Re: **Response to TEP Comments – Vadnais Heights Apartments Wetland Replacement Plan (LGU file 7.2024)**
Vadnais Heights, Minnesota

On behalf of Rueter Walton, Braun Intertec has responded below to the TEP comments on the Vadnais Heights Apartments Wetland Replacement Plan. Each number in the list below corresponds to the comments received in Findings Regarding the Vadnais Heights Apartments (Replacement Plan) Project, Project No. 7.2024, dated August 12, 2024.

ARCADE ST. APARTMENTS
 VADNAIS HEIGHTS, MN

SITE DEMOLITION PLAN
C1-1

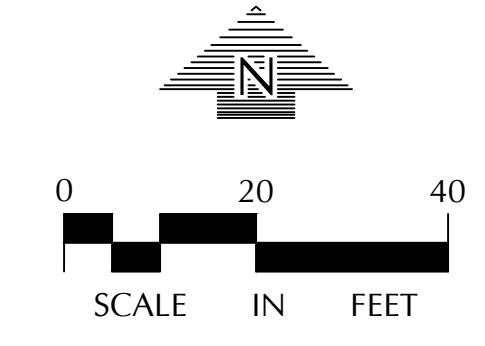
4. The application materials and August 9th response demonstrated a second alternative with reasonable modifications to the size, scope, and configuration or density of the project, and a discussion as to why this second alternative is not feasible. For illustrative purposes, the second alternative is shown on the attached figure (Alternative #2), showing approximately 0.25 acres of buildable upland when considering structure lot line setbacks of 10 feet from Arcade Street and 35 feet from side lots. Information provided by the applicant satisfies MN Rules 8420.0520 Subp. 3.C(3)(c).
